Keeyask Engineering Review

Jan 30 2017

Overview – KCB Review Scope

IFC Drawing Revision Log

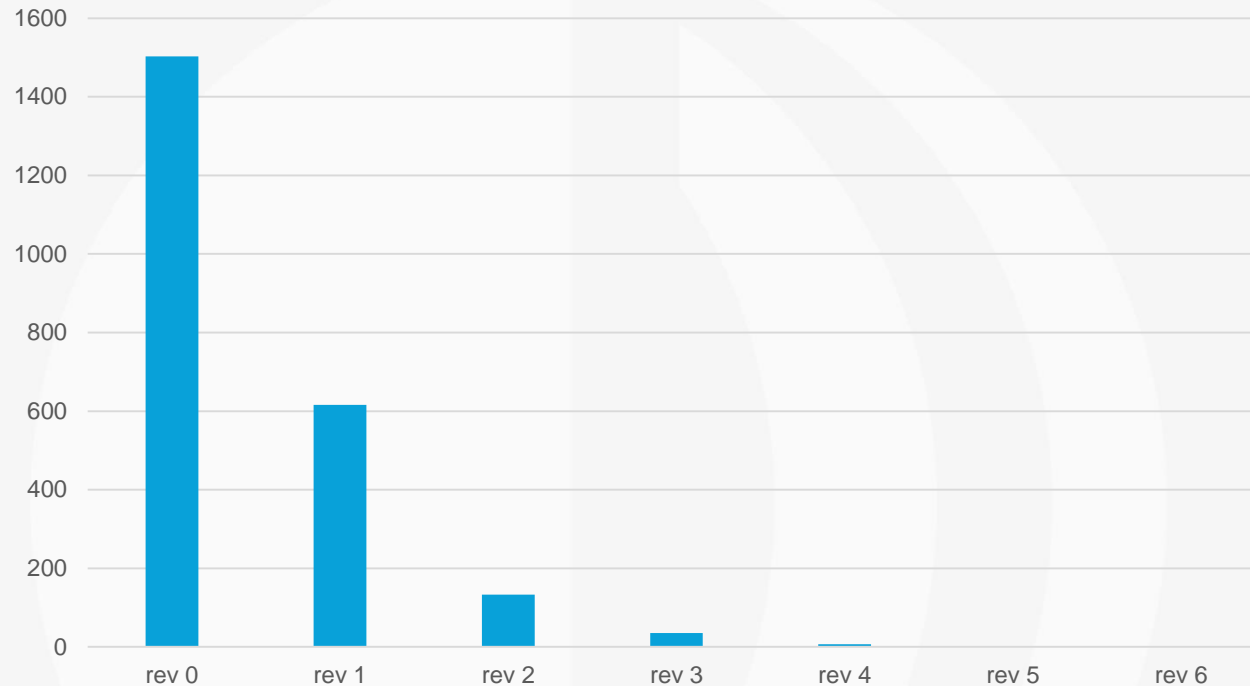
- The vast majority of the drawings have not been revised after issued IFC.
- This is good from the perspective of limiting the engineering effort and proof that the engineering was almost always on target and not being questioned by the contractor.

IFC Drawings Issued by Year

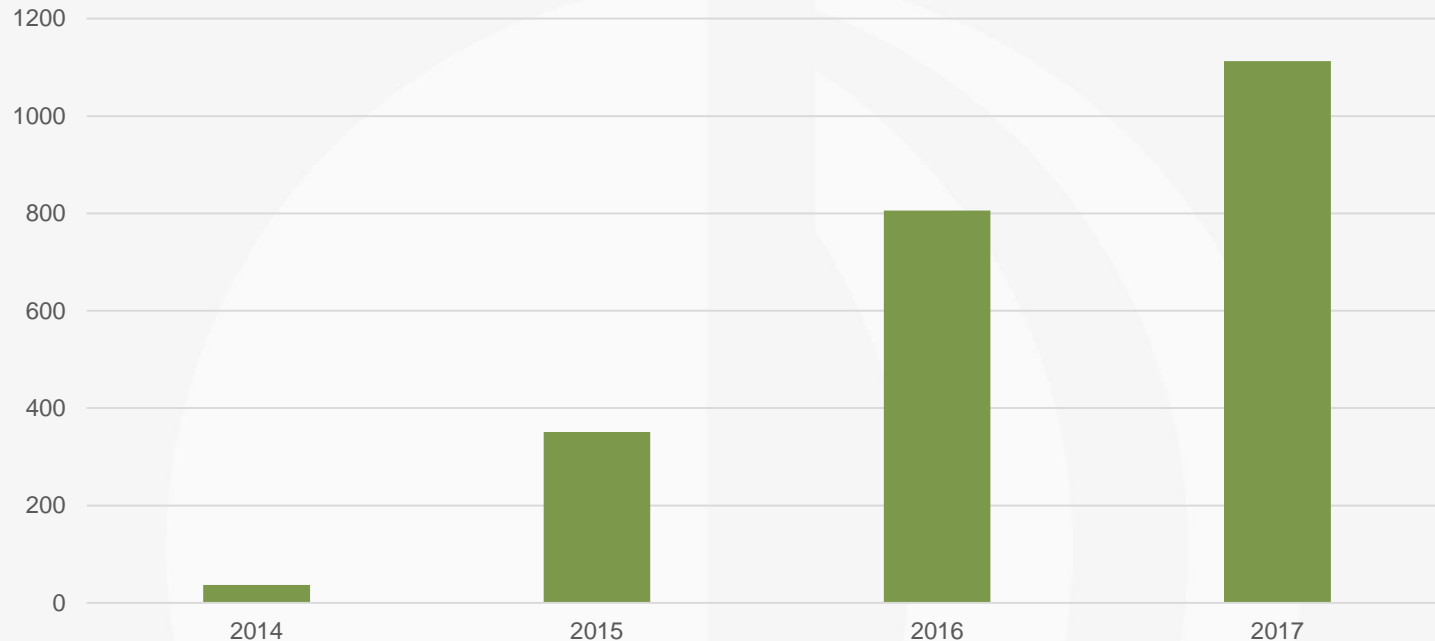
- In 2014 the contractor priced the job with a limited number of drawings. The majority of the drawings were prepared in 2016 and 2017 which may have created two issues which could impact the costs:
 - The contractor missed or did not allow for the complexity of the project – i.e. underbid
 - The engineer could have added more detail and work after the contract was signed.
